A G E N D A

Architectural Review Board

August 28, 2018

LAND USE DIVISION

3123 Norman Bridge Road

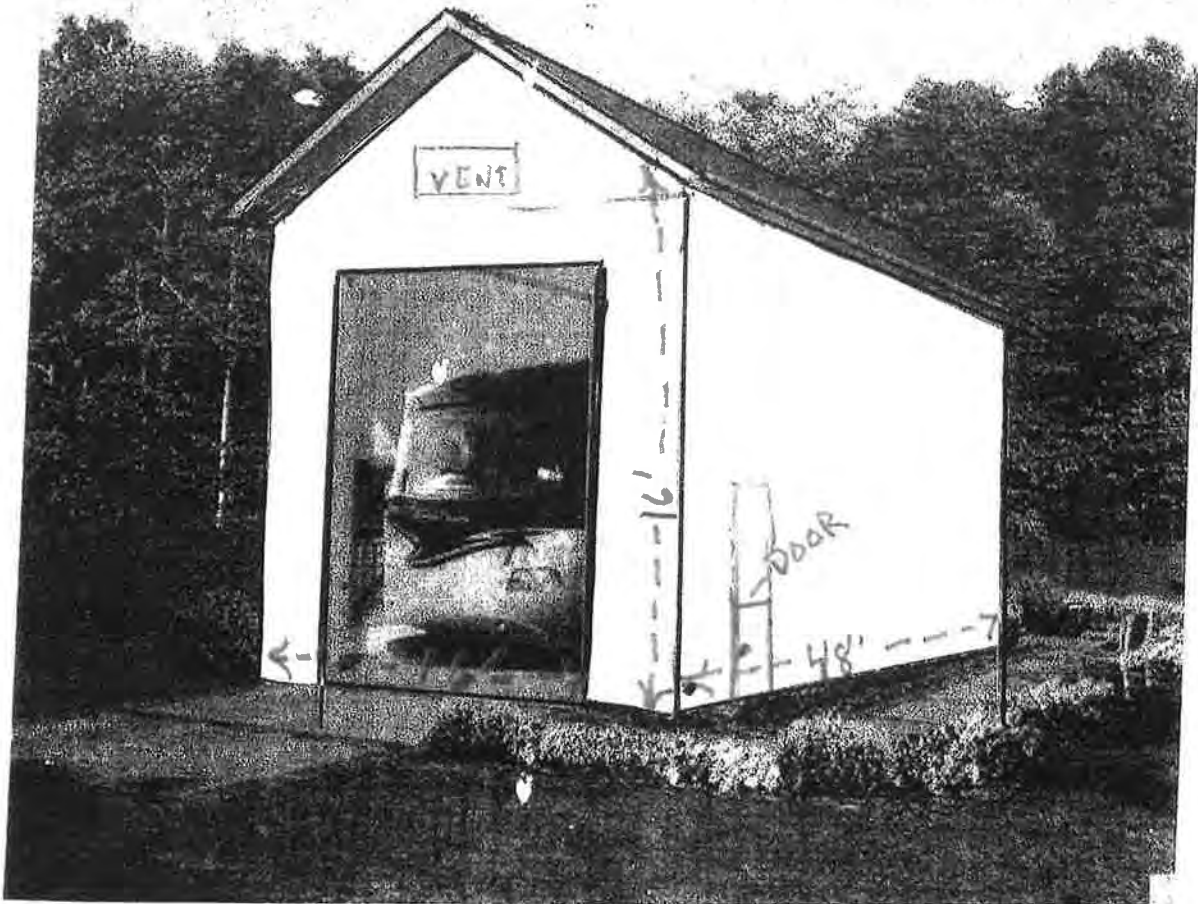
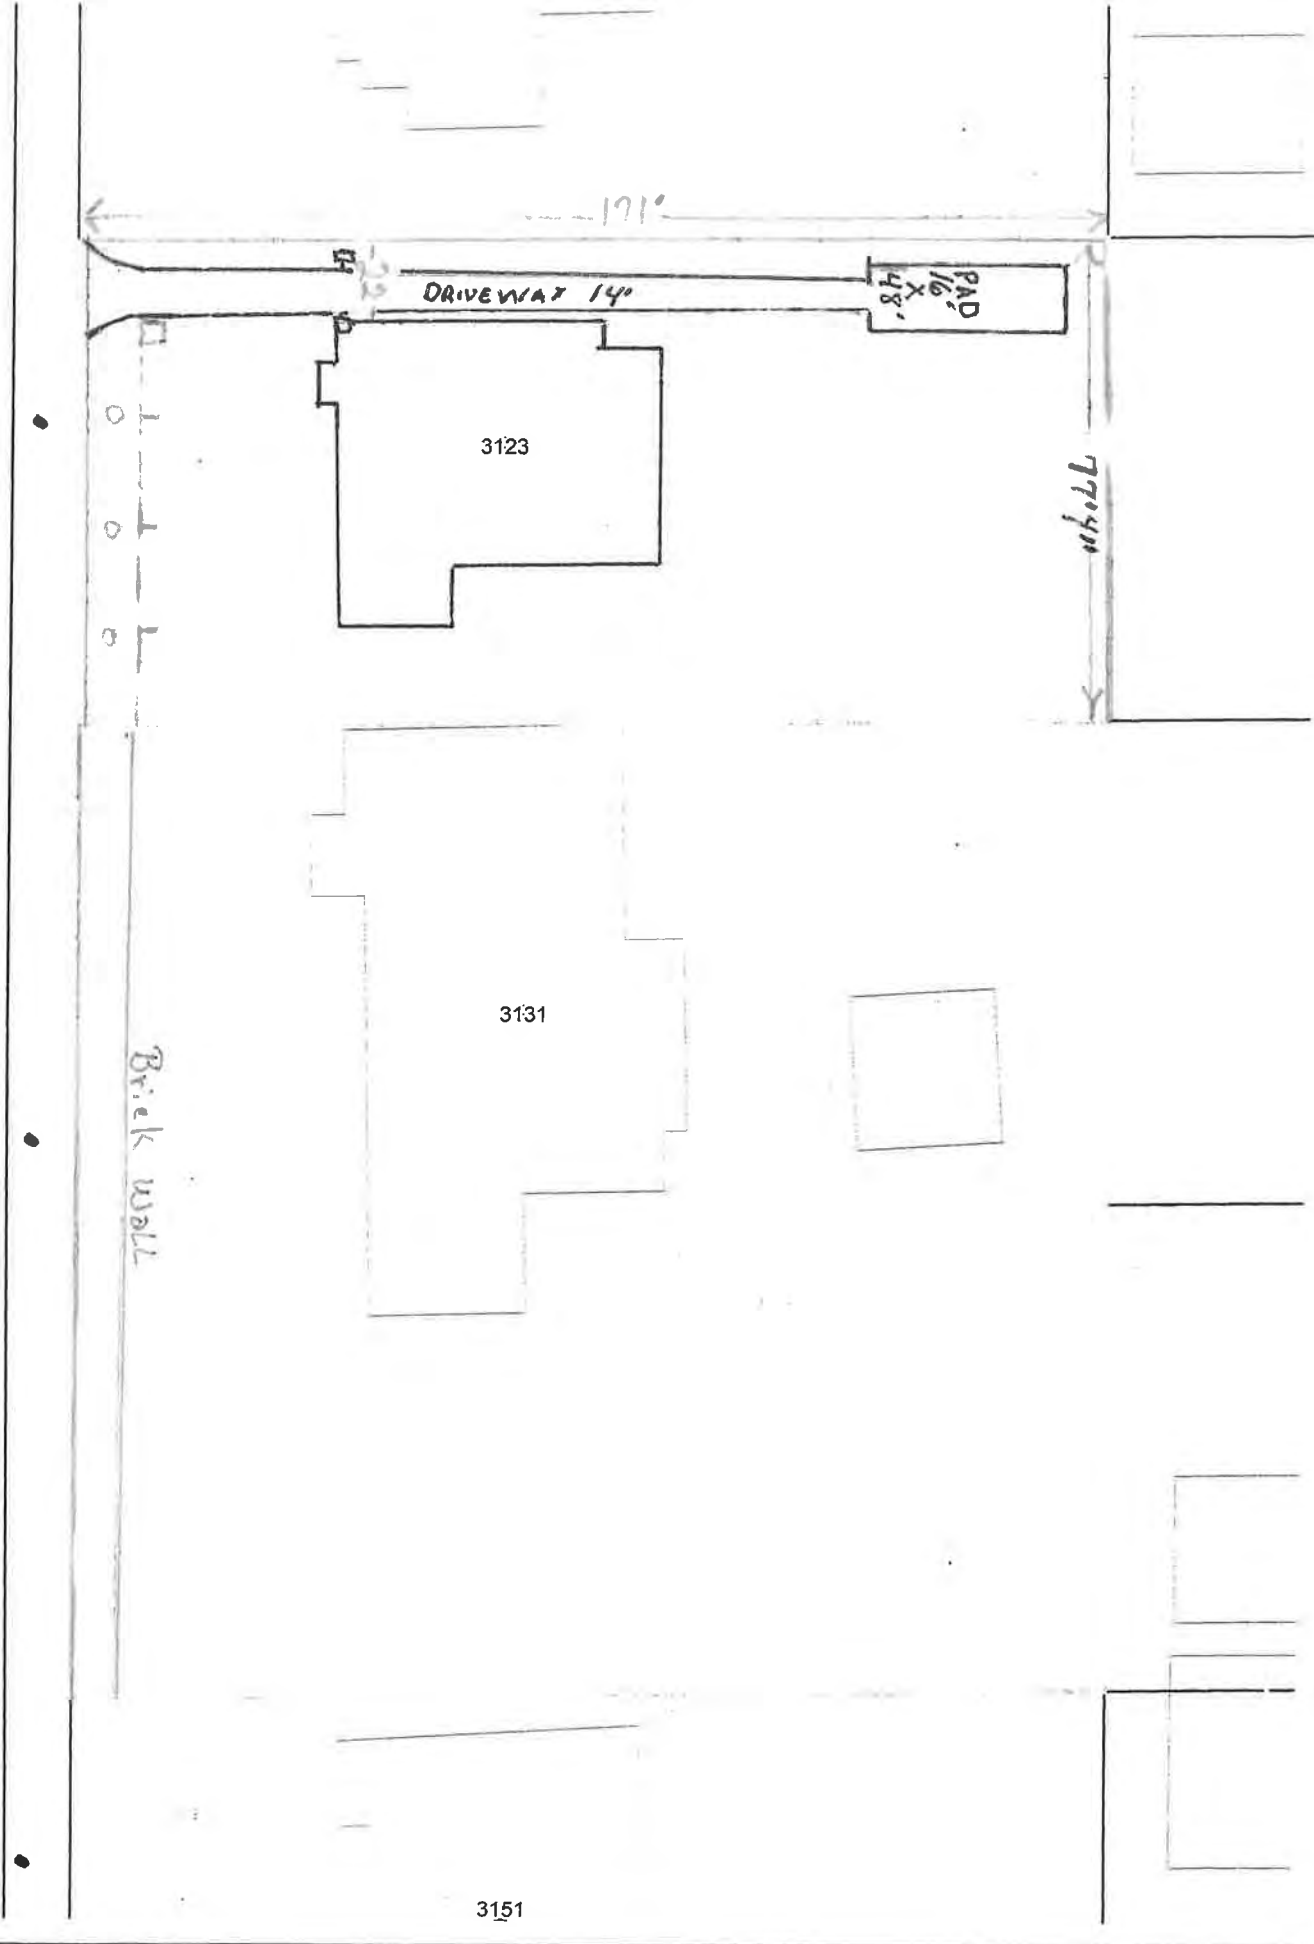
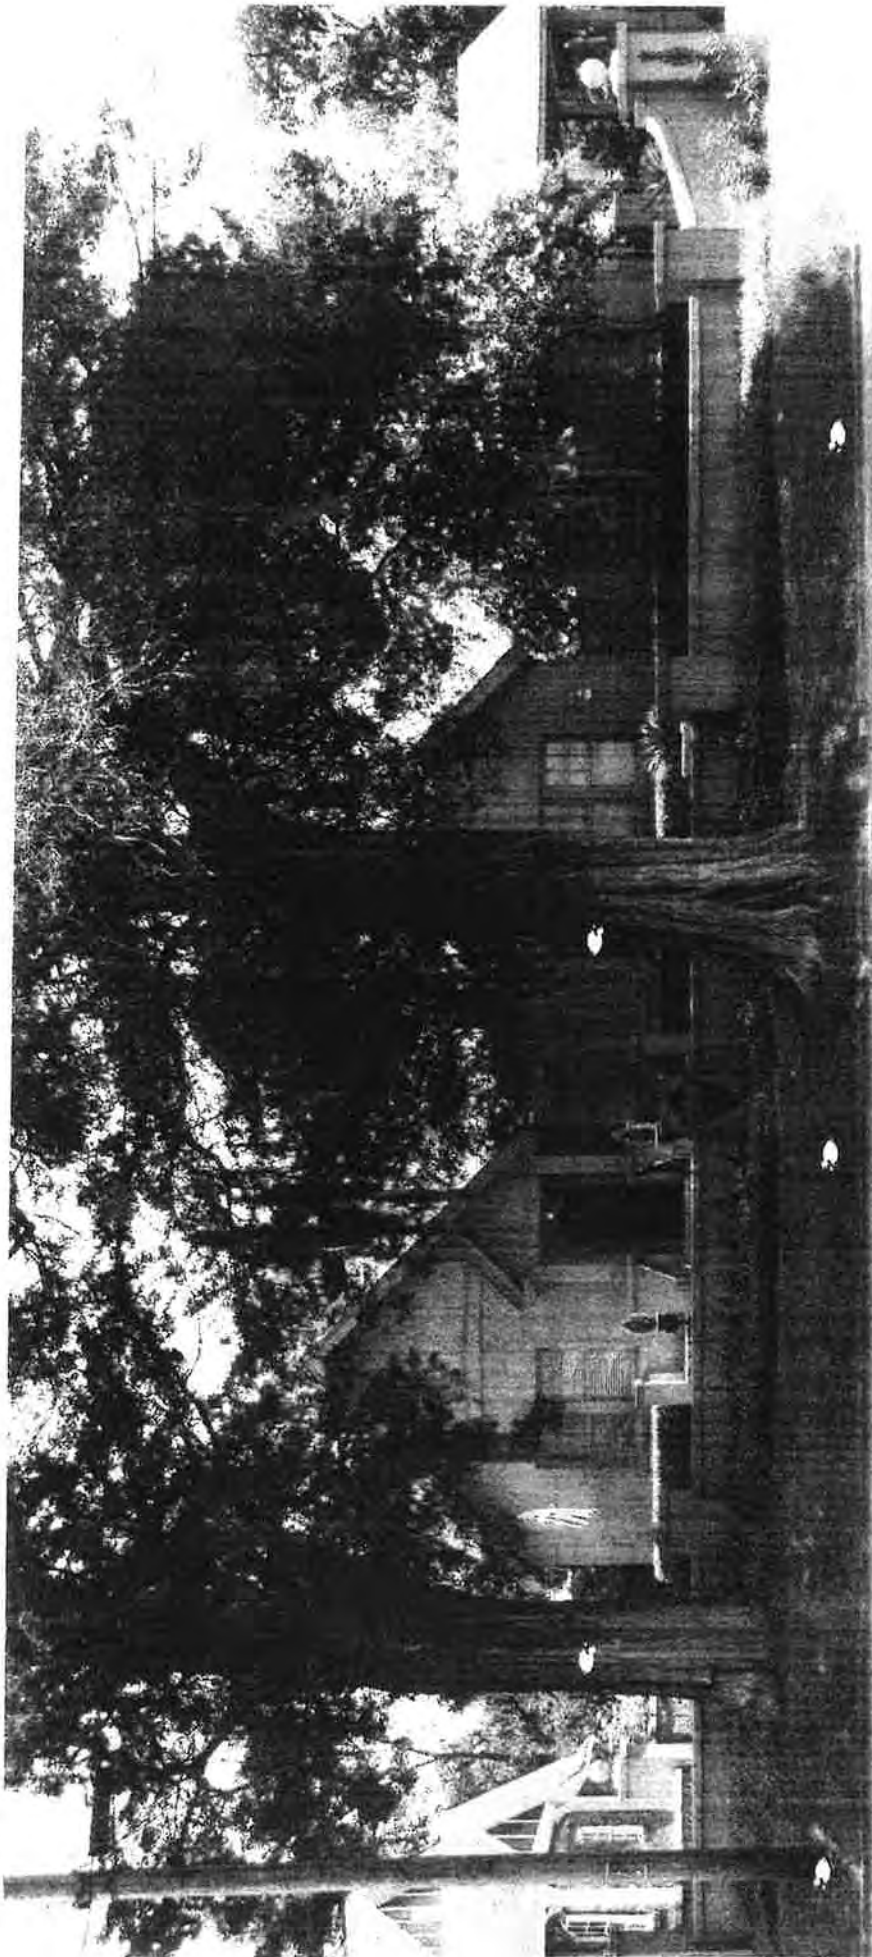
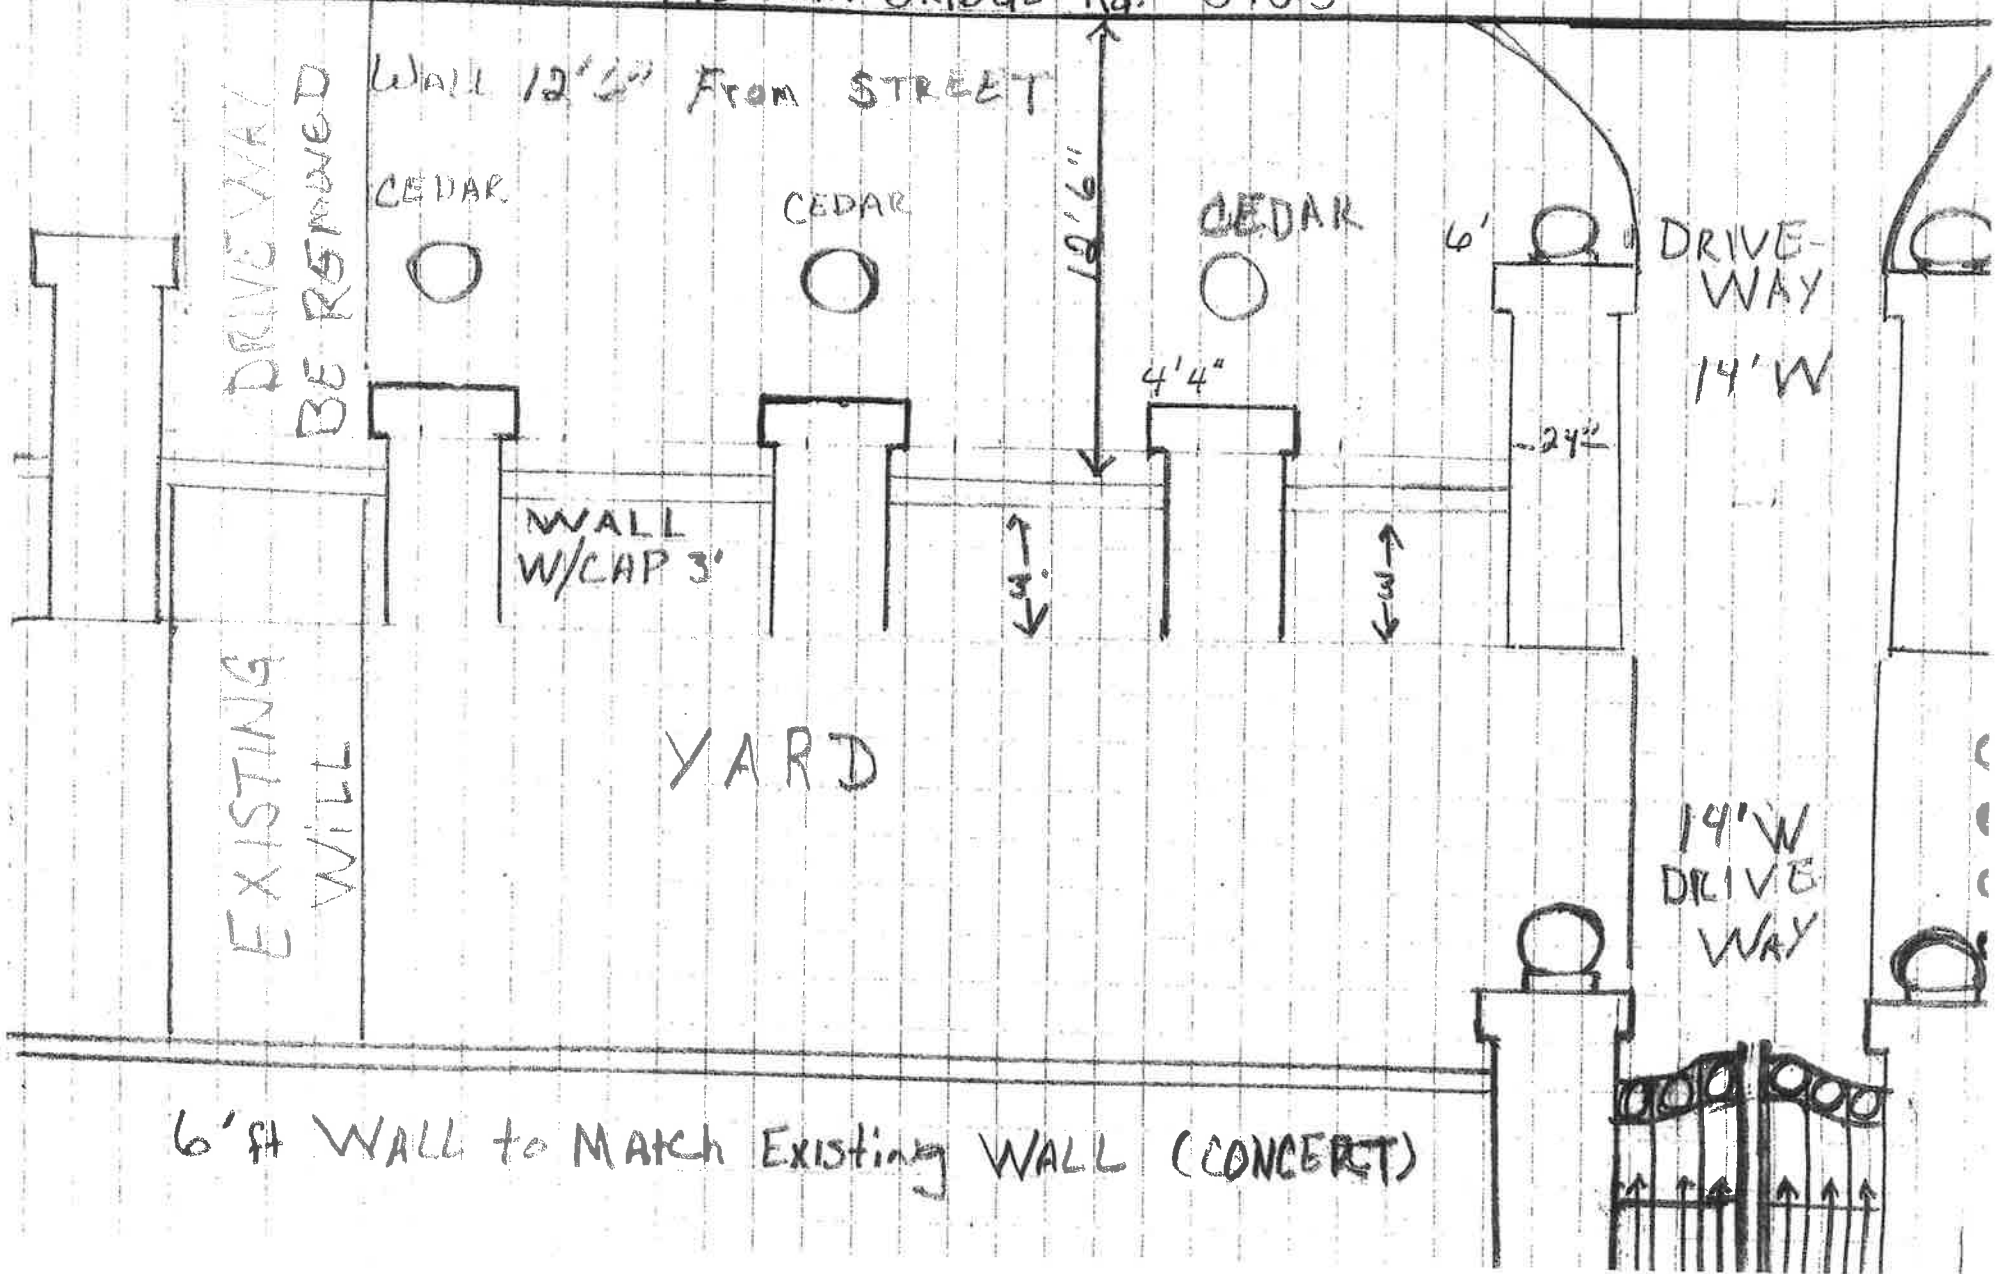
REMARKS: The petitioner is requesting permission to create a new curb cut and driveway on the north side of the property; construct an RV storage building at the rear of the property; and construct a wall on the front property line to match the wall on the adjacent property at 3131 Norman Bridge Road.

- Driveway. Proposed driveway will be concrete, 14' long and extend within 3' of the rear property line.
- RV Storage. The proposed structure will be open at the front and have a 16'x48' footprint, and 16' wall height (no height to ridge given). There will be a square gable vent and a single walk through solid 3' door. A dryvit sand finish to match the house at 3131 Norman Bridge is proposed, matching corner and opening details with keystones, quoins (see accompanying photos). Roof will be shingled in Weathered Wood Architectural Shingle.
- Concrete wall with cap, dryvit sand finish to match existing wall on front property line. Wall height 3'; driveway columns 6'; intermediate columns 4'4".

The Board should disregard the 6' wall proposed in line with the gate at this time. It encroaches on the footprint of the house, which Mr. Harris does not have permission to demolish. Mr. Harris will also need to visit the Board of Adjustment to request variances for coverage, wall column height, and setbacks.

- The Board needs to determine if the scale, material, and placement of the RV storage building is appropriate.
- New curb cut needs to meet City Engineering's turnout requirements.
- There is no record of the wall Mr. Harris wants to match at 3131 Norman Bridge Road having been approved by ARB or Board of Adjustment. It was not in the photos at the time of his 2004 submission to building a garage.
